PUBLIC MEETING TOWN OF HUDSON, NH **FEBRUARY 26, 2014**

Boyer Site Plan - 156 Lowell Road

PLAN UNDER REVIEW ENTITLED: Non-Residential Site Plan Boyer Site, 156 Lowell Rd. Map 204 Lot 075, Hudson, NH, prepared by Keach-Nordstrom Associates, Inc., dated: Nov. 12, 2013, latest revision date Feb. 17, 2014, consisting of Sheets 1 - 11 and Notes 1 – 23 (said plans are attached hereto).

Boyer Site Plan Tax Map 204, Lot 75 KNA#06-0808-2

REVISI	enc	
No.	DATE	Di	ESCRIPTION	BY
1	1/8/14	RESPONSE	TO CLD COMMENTS	100
DATE	: NOVEMBER	12, 2013	SCALE: 1" = 40'	
	ECT NO: Of		SHEET 1 OF 11	_

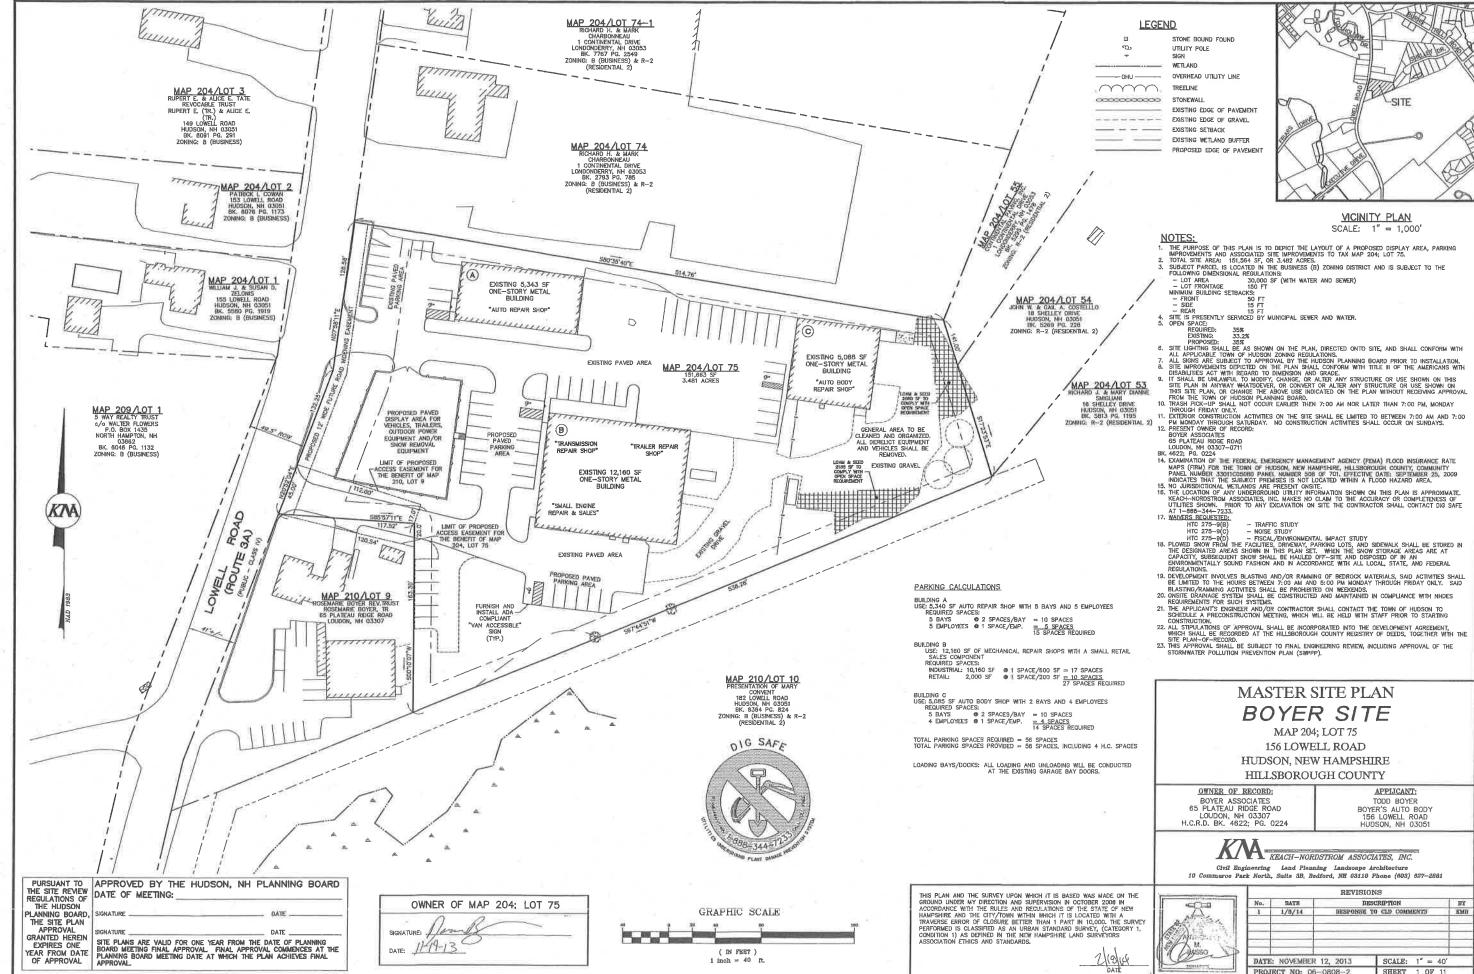
- 1) Gravel parking area behind 160 Lowell Rd., Map 210/Lot 009 (Boyer house and former Granite State Glass commercial building). These spaces have been moved, as requested by the board, so that now they are located entirely on Map 204/Lot 75. Please refer to Sheet 1 of 11.
- 2) The 12' Wide Future Road Widening Easement is shown on the revised Plans, together with the Access Easement for the benefit of Map 210/Lot 9 and Map 204/Lot 75. See details of said easements on Sheet 1 of 11. The subject easement deeds will be prepared and favorably reviewed by Town Counsel prior to Planning Board endorsement of the Site Plan-of-Record.
- 3) Green space has been added to the Plans to conform to the regulations. See 2 areas to the rear of the parcel labeled: "Loam & Seed...", Sheet 1 of 11.

- 4) Indicate the clean-up of the back area on the site. On the revised Plans, Sheet 1 of 11 a note has been added to this area of the parcel; it reads: "GENERAL AREA TO BE CLEANED AND ORGANIZED.ALL DERELICT EQUIPMENT AND VEHICLES SHALL BE REMOVED."
- 5) Landscaping, Lighting and Snow Storage Areas are all shown on the revised Plans. See Sheet 7 of 11.

We have shown the apparent utilities visible at the time of field survey. Many underground utility locations are unknown. We have reviewed the water, sewer and gas service cards and added the locations noted to the plans. No other records have been discovered at this time so note 16 was added to sheet 1.

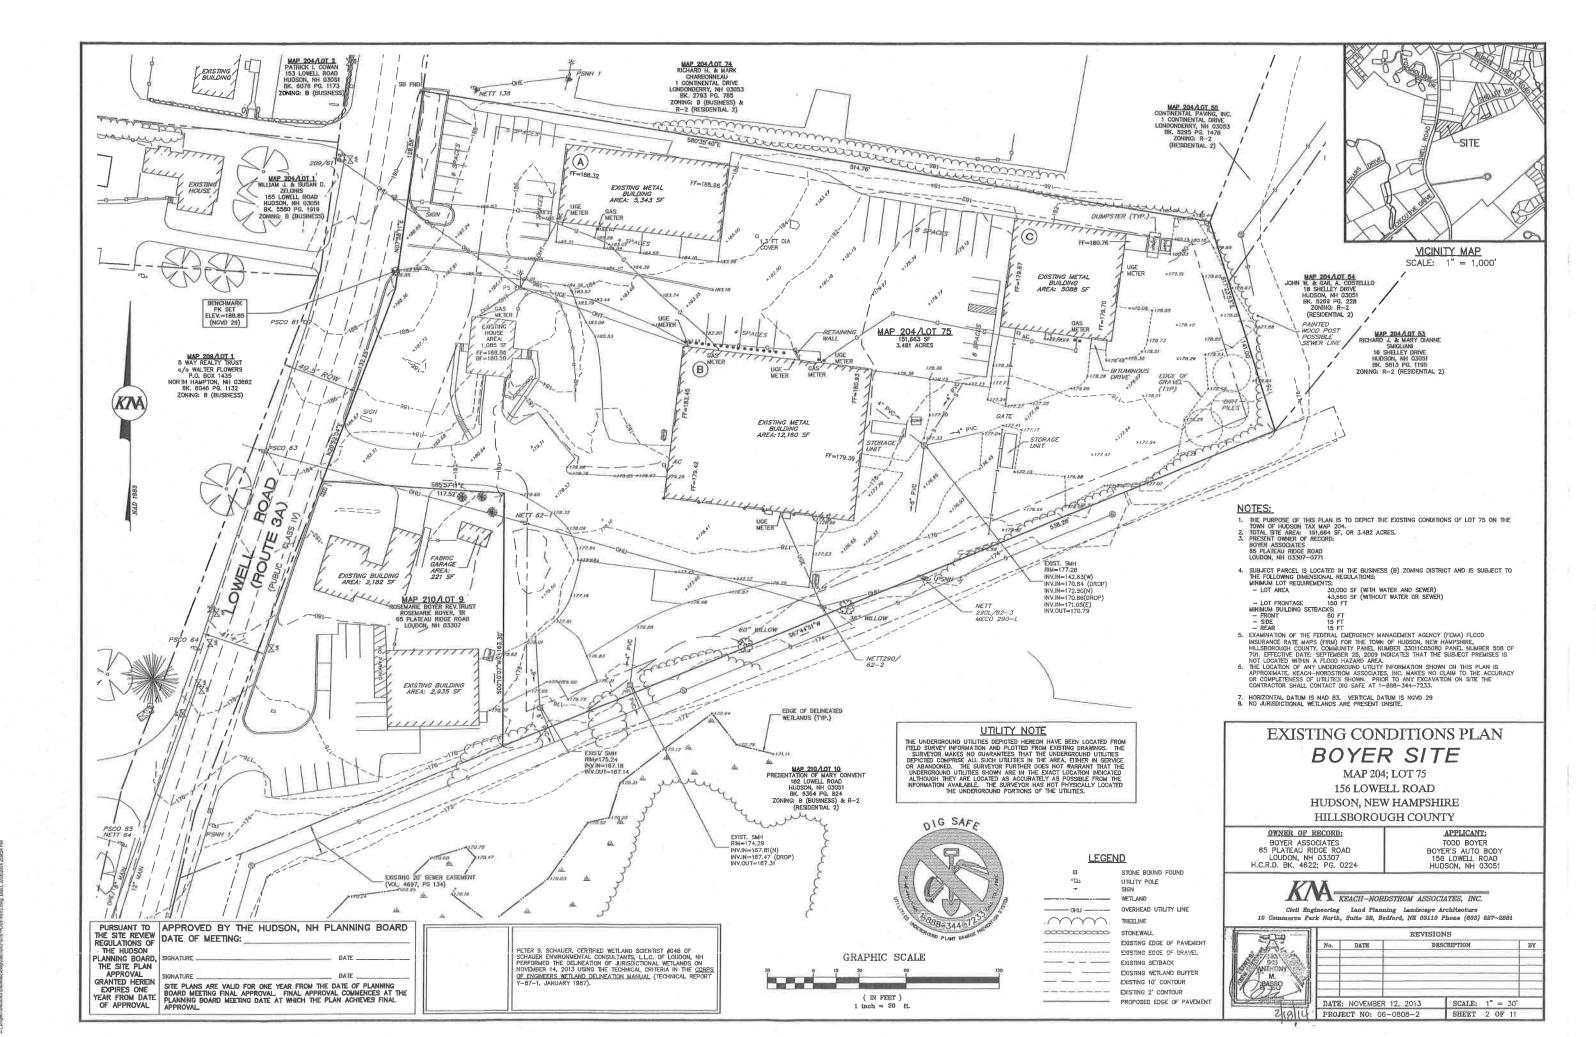
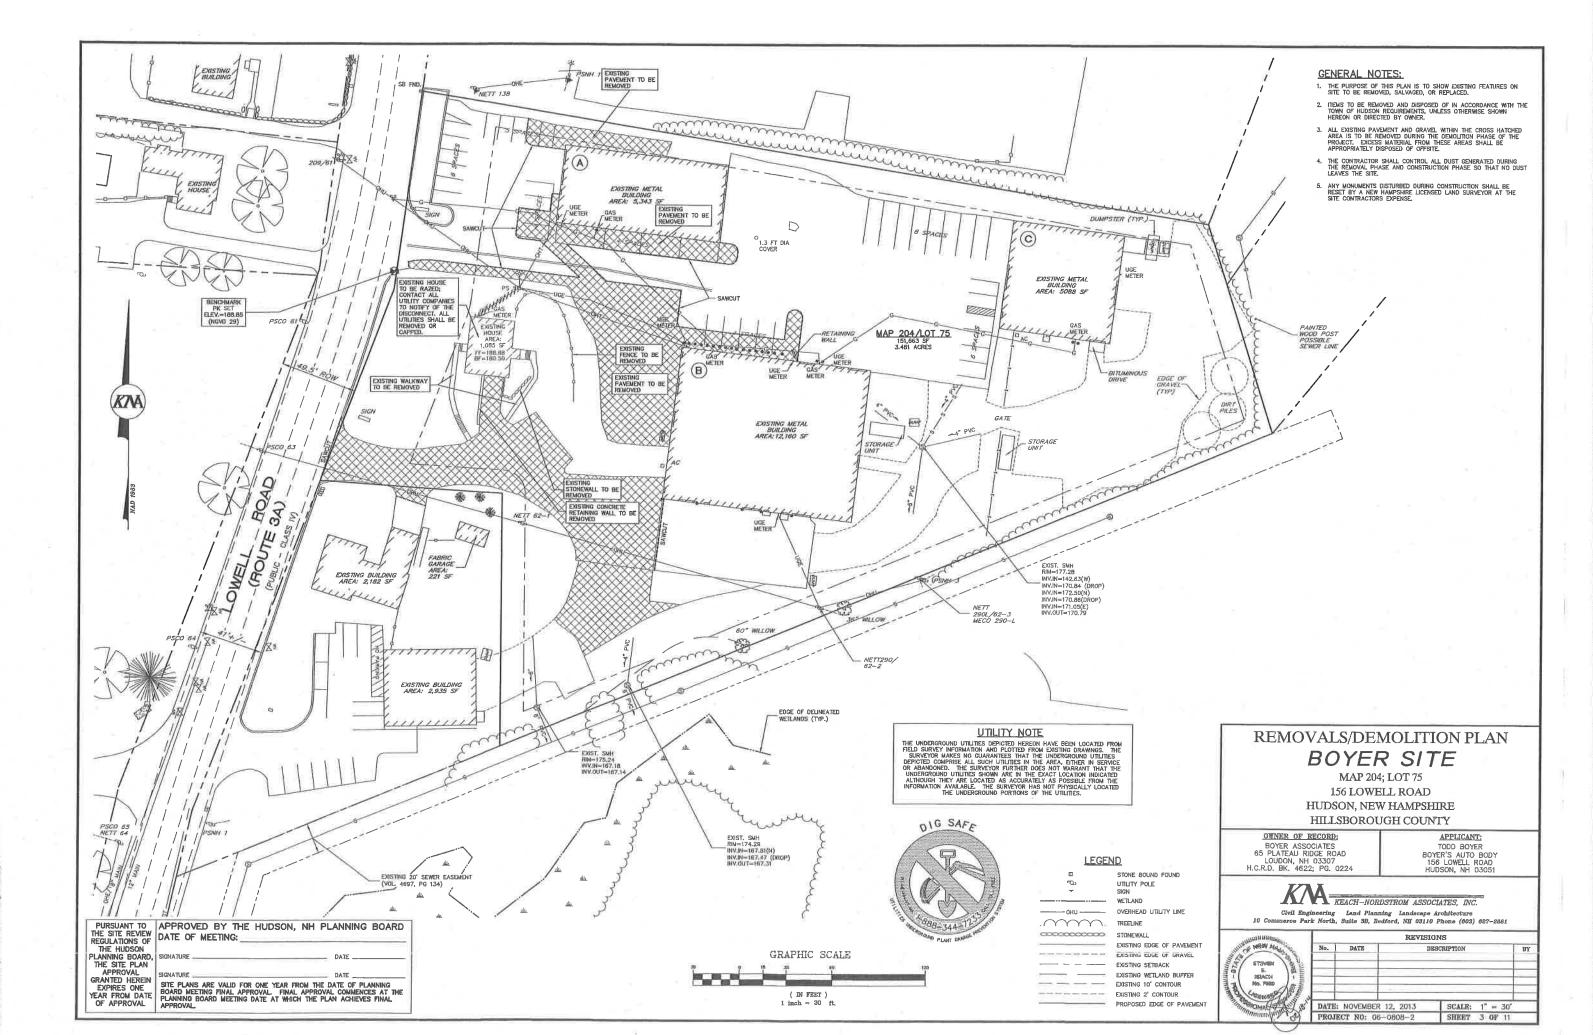
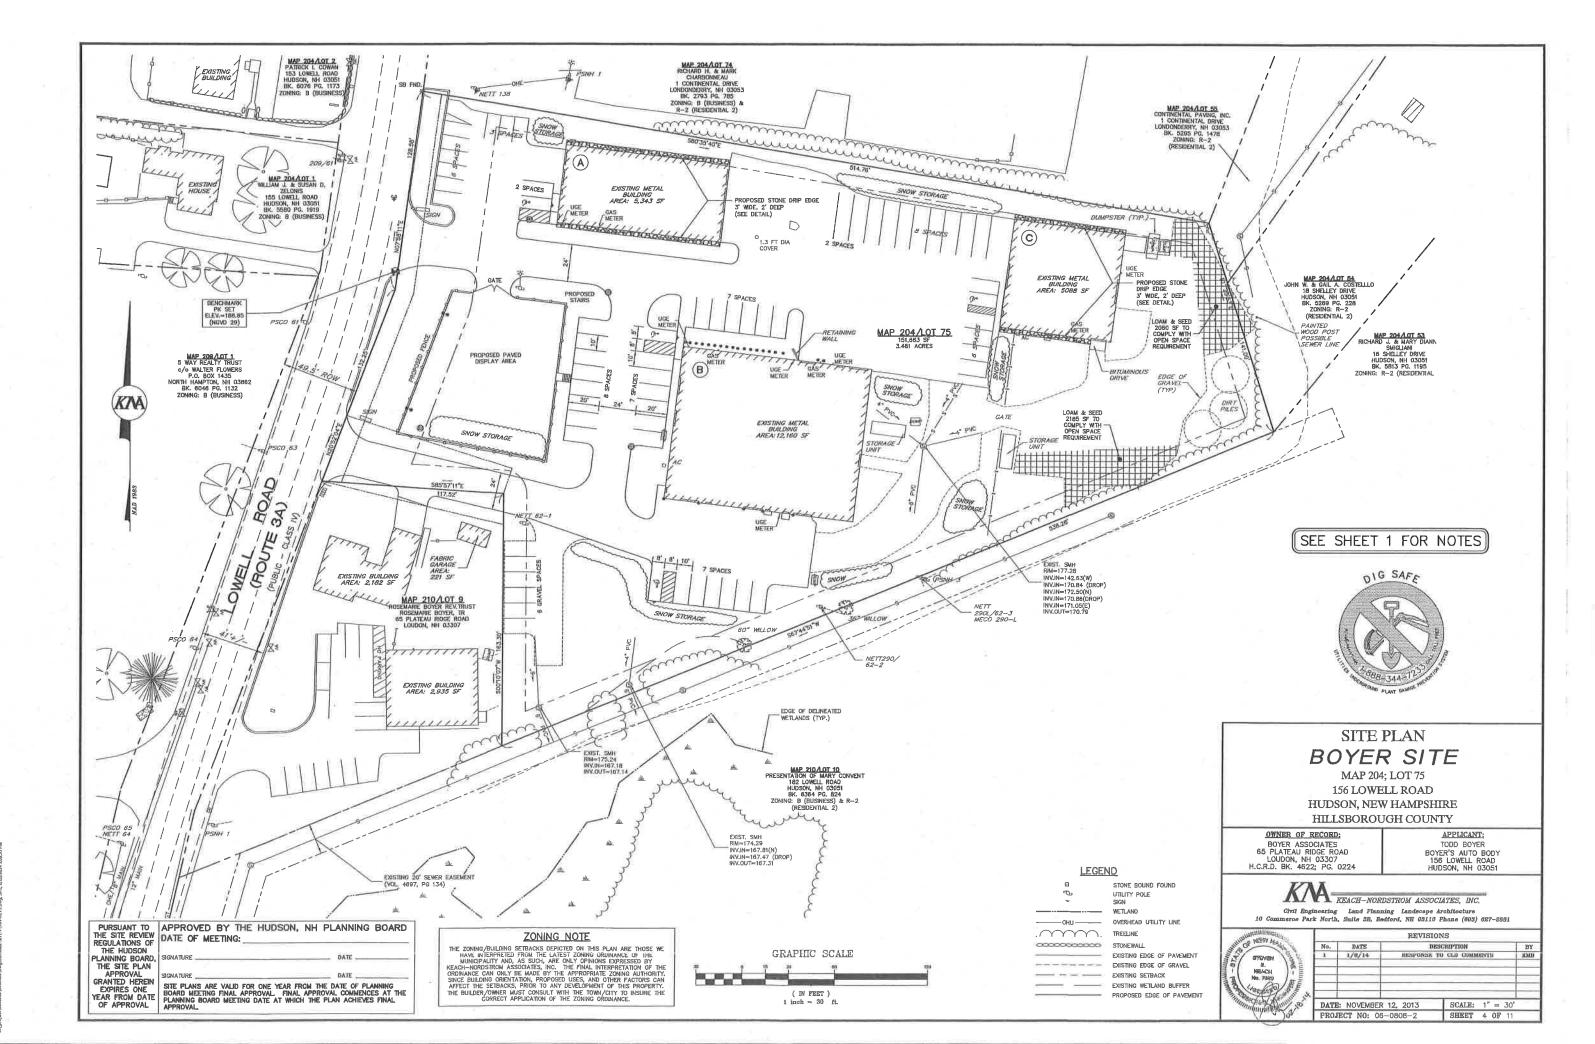
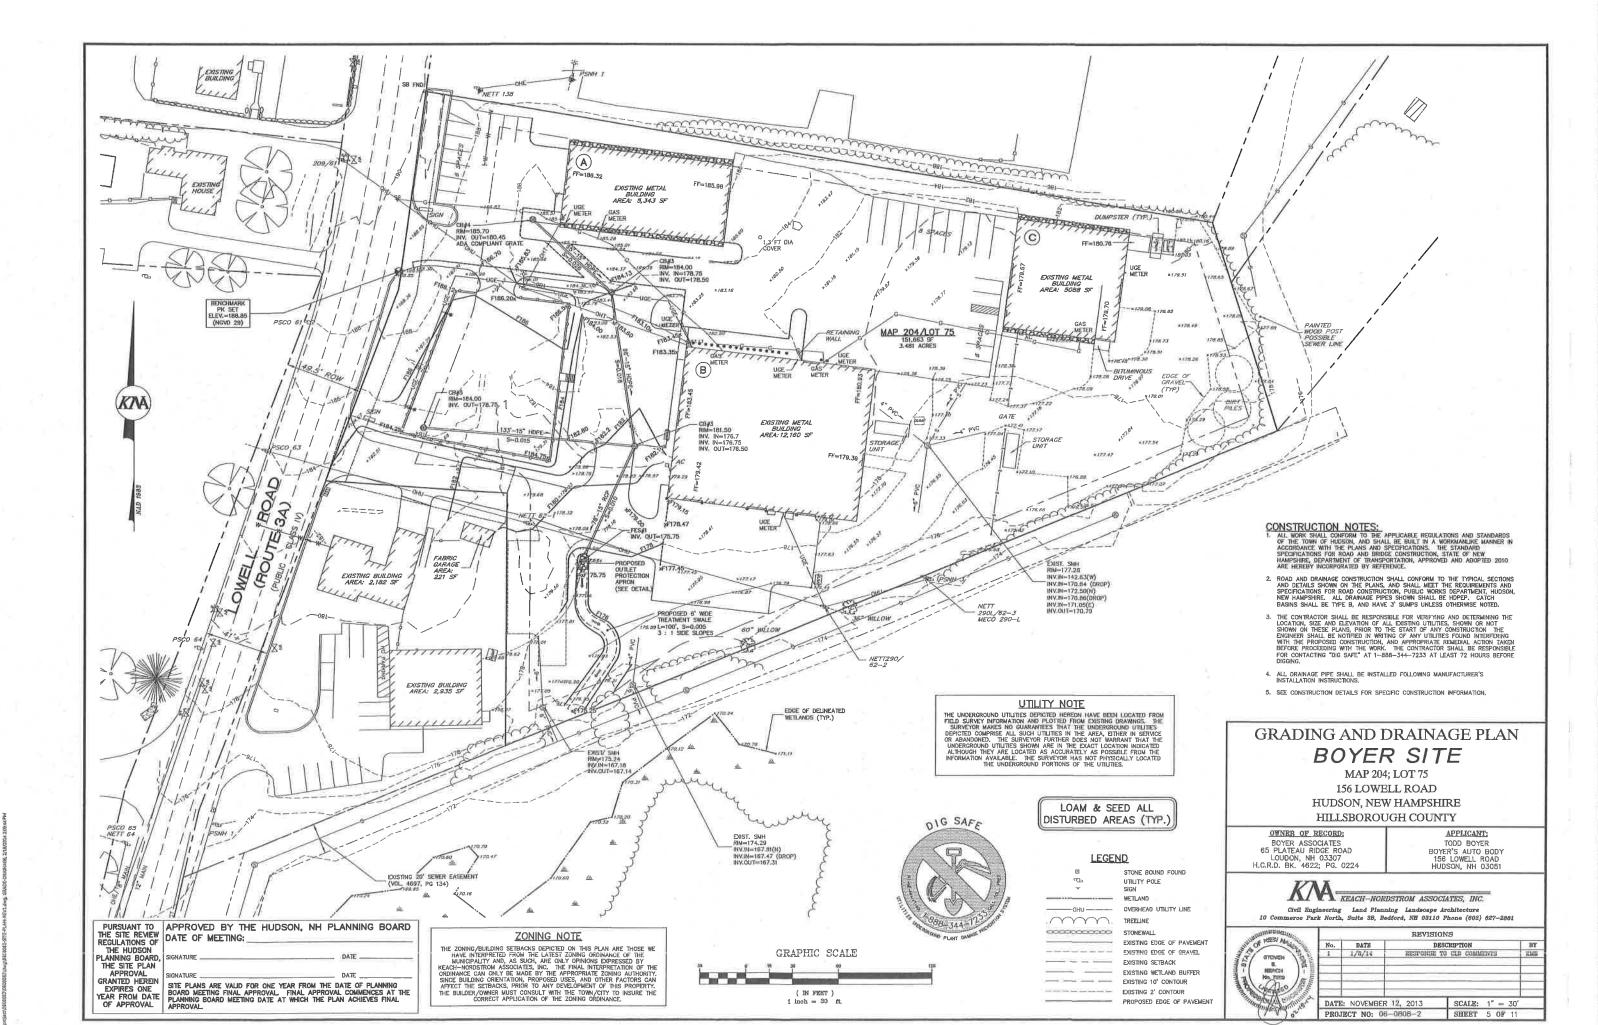
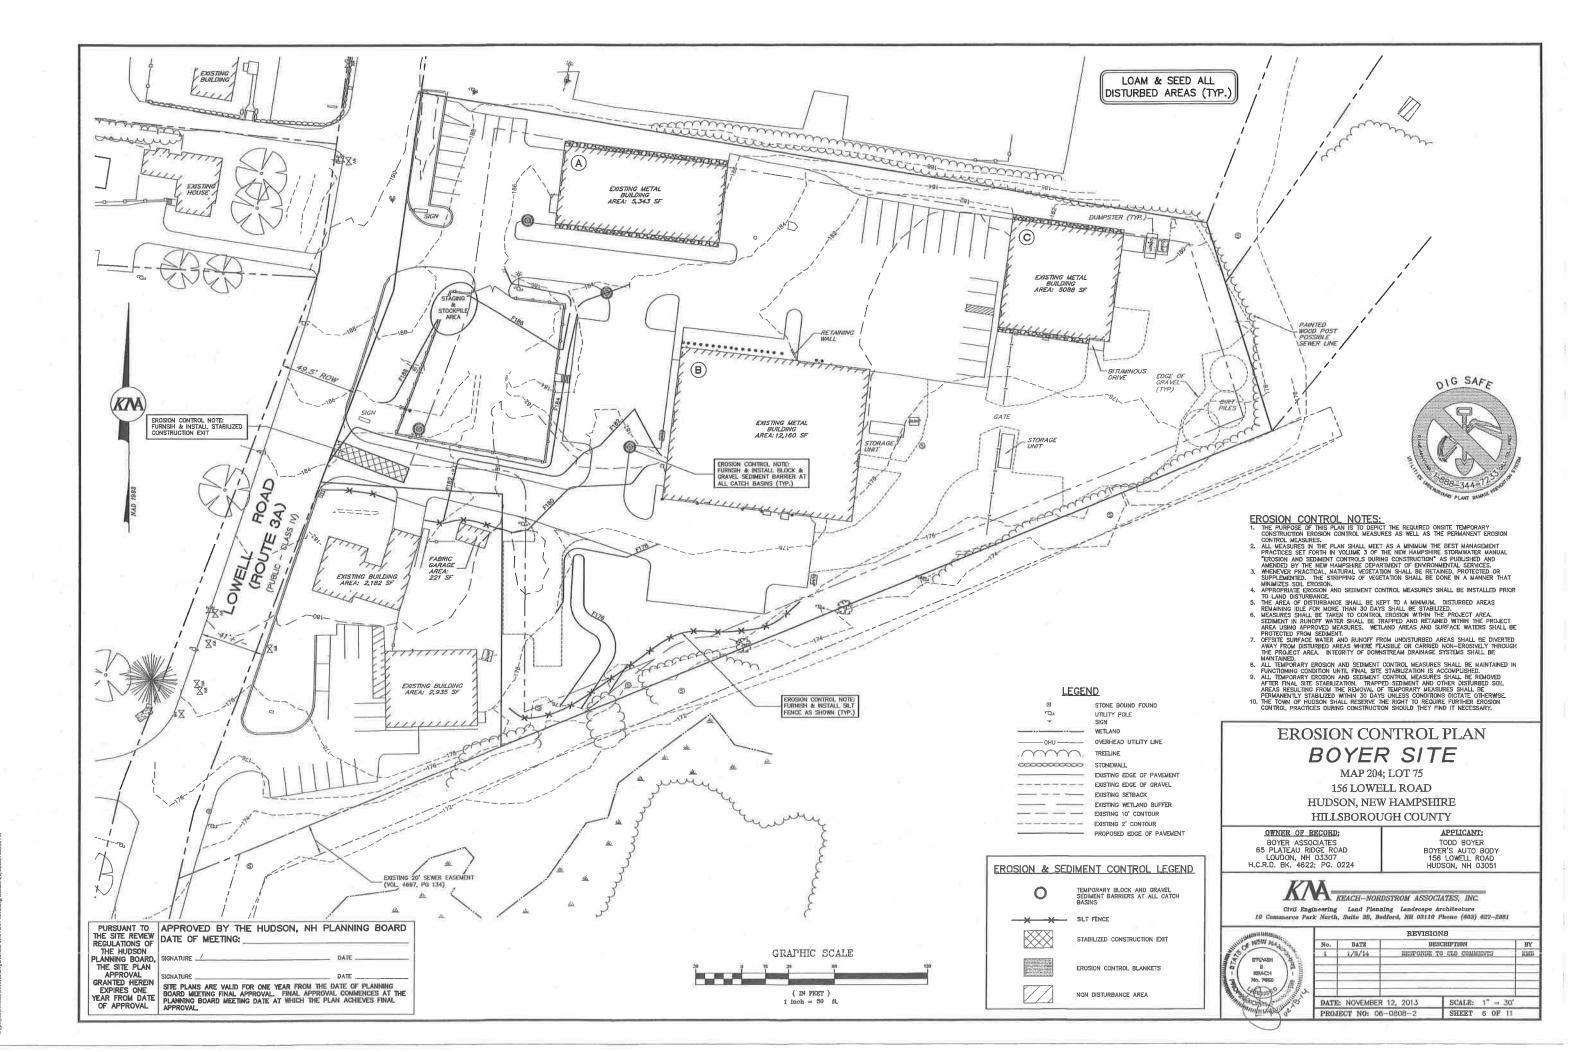
a. HR 275-8.B. (35) The applicant has shown four handicap parking areas and has provided corresponding details; however, the handicap van accessible sign location(s) are not shown on the plans or in the handicap striping detail. The applicant should also label American Disability Act (ADA) compliant building entrances and provide additional spot grades and ramp details, if necessary. (We were unable to find any ramp detail on the plan set.)

Signs have been added. All building entrances are existing and do not have ramps, therefore a ramp detail is not shown.
